SERVICE INFORMATION BULLETIN

APPLICABILITY: 2018-20MY Crosstrek
2019-20MY Forester

NUMBER: 12-296-20

SUBJECT: Rear Frame and Stabilizer Bar Bracket
Mounting Bolt- Design Changes

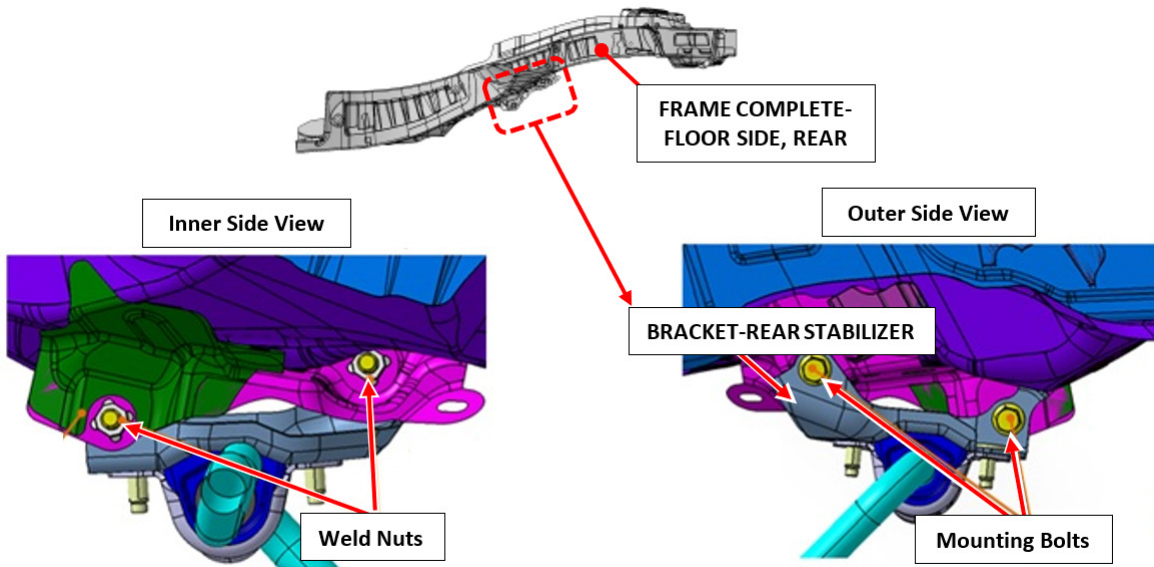
This Service Information Bulletin outlines design changes made to the rear frame sections and the mounting bolts used to secure the rear stabilizer bar brackets to them. In RARE cases, the rear stabilizer bar bracket mounting bolts may loosen. To address this condition, the mating surfaces for the stabilizer bar brackets have been revised, the flange bolts securing the brackets and the weld nuts incorporated into the frames have been optimized to enhance torque retention. In the RARE case where any of the stabilizer bar bracket bolts are found to have loosened, simply re-tighten to the specified torque (35 Nm / 25.8 ft. lbs.) as the gap referenced previously has already been closed during vehicle assembly. Replacement of the bolts and/or bracket is not necessary as the original bolts are reusable. Always use the bolt(s) intended for use with the original factory installation as they are not interchangeable.

New Flange Bolt Identification Information:

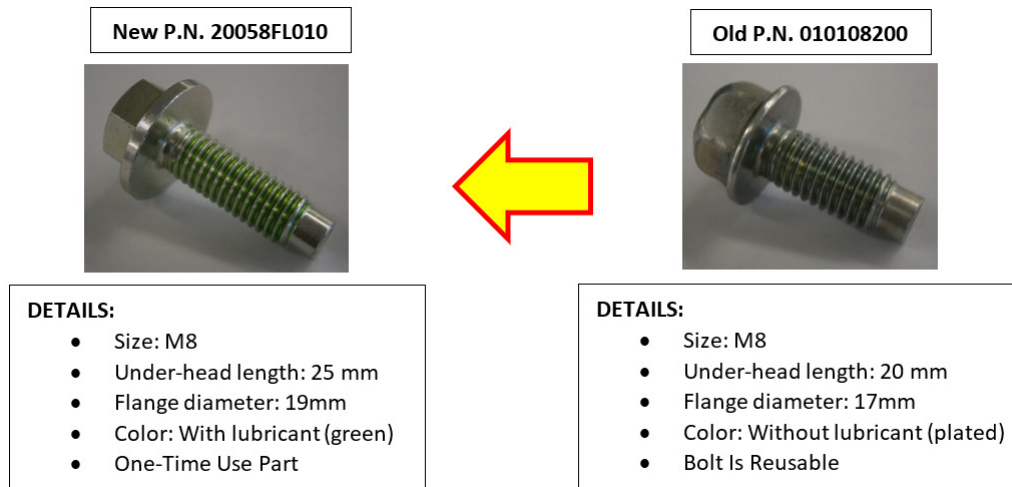
- The new Flange Bolts listed here are NOT compatible with weld nuts used in the original frames. Therefore, using the new-style Flange Bolts on the original frame will damage the weld nuts.
- The original Flange Bolts (p.n. 010108200) are reusable and readily available if needed.
- The new Flange Bolts have a special lubricant applied to their threads and are One-Time use.
- There have been no changes to the part numbers of the stabilizer bar brackets.
